AS3251™

BOLT, MACHINE - DOUBLE HEXAGON EXTENDED WASHER HEAD, DRILLED, PD SHANK, SILVER PLATED, NICKEL ALLOY, UNS N07718, 185 KSI MIN, .2500-28 UNJF-3A

AS3251™  
SHEET 1 OF 3

ISSUED 1980-07 REAFFIRMED 2007-06 REVISED 2018-11

FIGURE 1 - BOLT

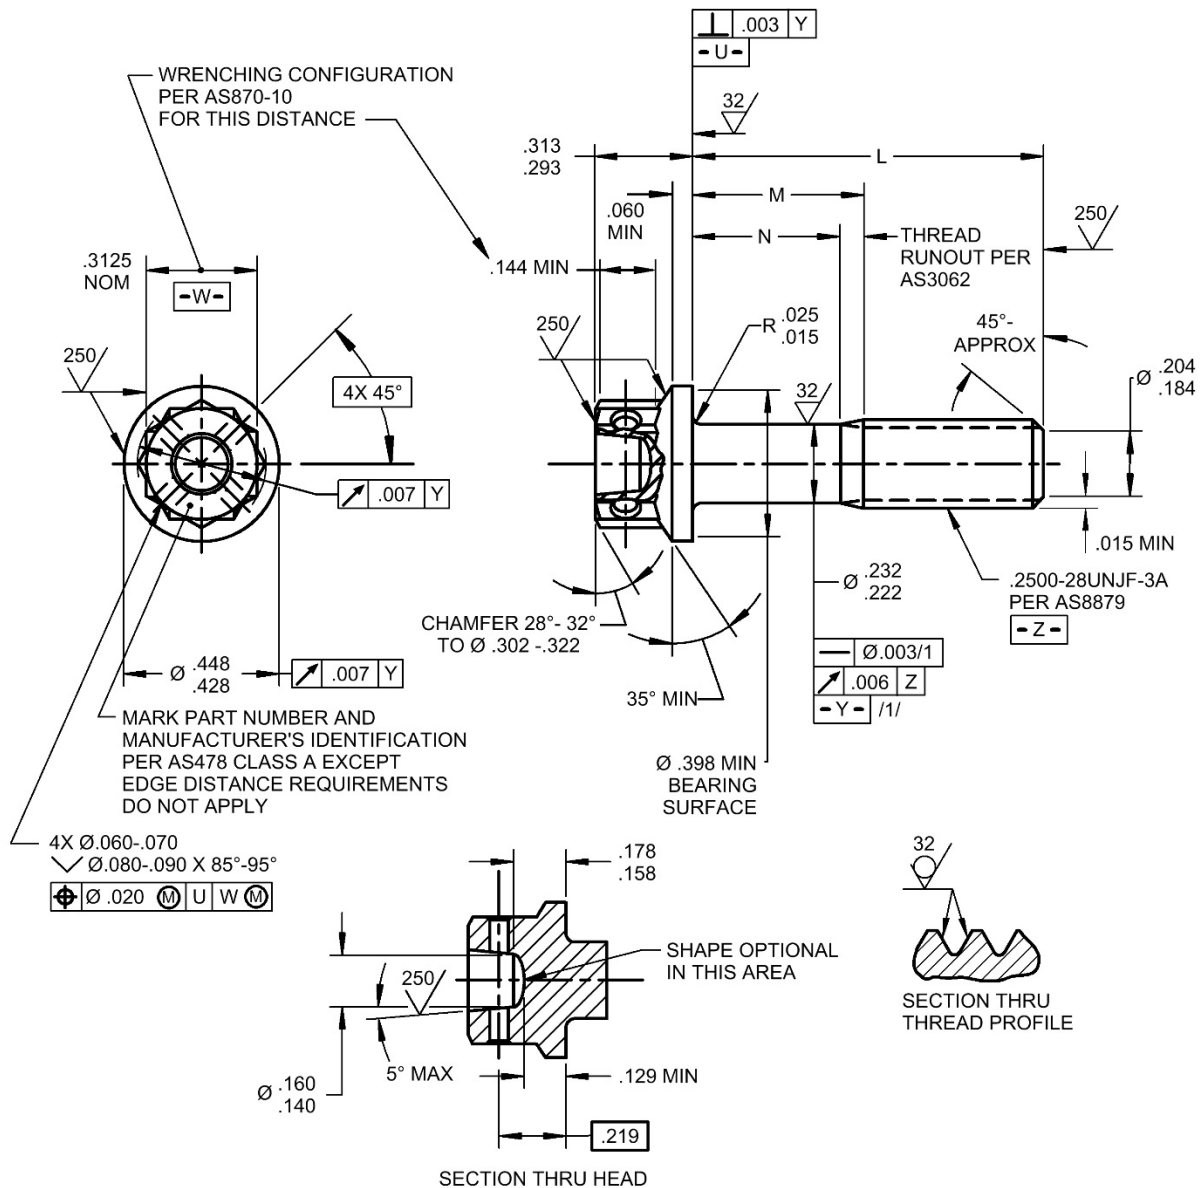
REVISE LEAD THREAD CHAMFER REQUIREMENT TO AS1132 STANDARD, UPDATE FPI NOTE, ADD NEW NOTE FOR DISPOSITION OF EXISTING INVENTORY, MINOR UPDATING TO ASME Y14.5M FORMATS, GENERAL EDITORIAL UPDATE.
